Economic Commission for Europe**Inland Transport Committee****World Forum for Harmonization of Vehicle Regulations****Working Party on General Safety Provisions****113th session**

Amendments to regulations on buses and coaches:**Regulation No. 107 (M₂ and M₃ vehicles)****Proposal for Supplement 7 to the 06 series of amendments and Supplement 2 to the 07 series of amendments to Regulation No. 107 (M₂ and M₃ vehicles)****Submitted by the expert from the Czech Republic***

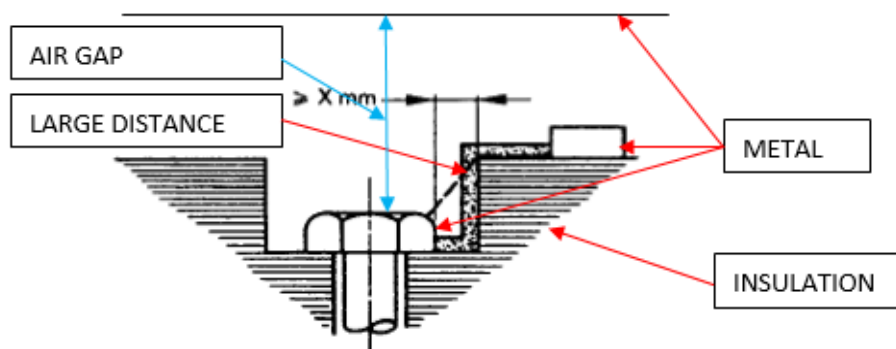
1. Reinforced insulation is generally used in many cases of double insulated systems, e.g. in case of a power screw terminal inside of a metal box of inverter, there is an air gap with a large distance between the screw and the metal lid: this air gap is considered as "reinforced insulation" as shown on the following figure on "AIR GAP" and "LARGE DISTANCE".

2. The designation of "reinforced insulation" is not defined in paragraph 1.3. of Annex 12. Nevertheless, this is not the main problem. European standard EN50124-1 provides the best technical specifications on how to design correctly the insulation. There are also explanations on double insulation and reinforced insulation, including definitions, tables of clearance, creepage distance and test procedures. Conventional trolleybuses and trolleybuses with Rechargeable Energy Storage Systems (REESS), such as traction batteries or super-capacitors, shall be designed in accordance with this standard.

~~Reinforced insulation in trolleybuses is not allowed for circuits directly connected to overhead line.~~

Circuits directly connected to overhead line shall be double insulated."
